SERVICE BULLETIN 19092601

MODELS COVERED: 65PFL5704/F7, 65PFL5604/F7

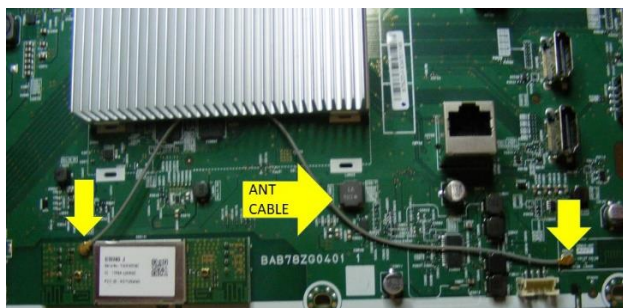
When replacing the Digital Main, the antenna cable must be removed from the defective board and installed on the new board.

Failure to move the cable will result in the lack of range for the microphone.

If the cable is missing order replacement cable WX1AB78ZW611.
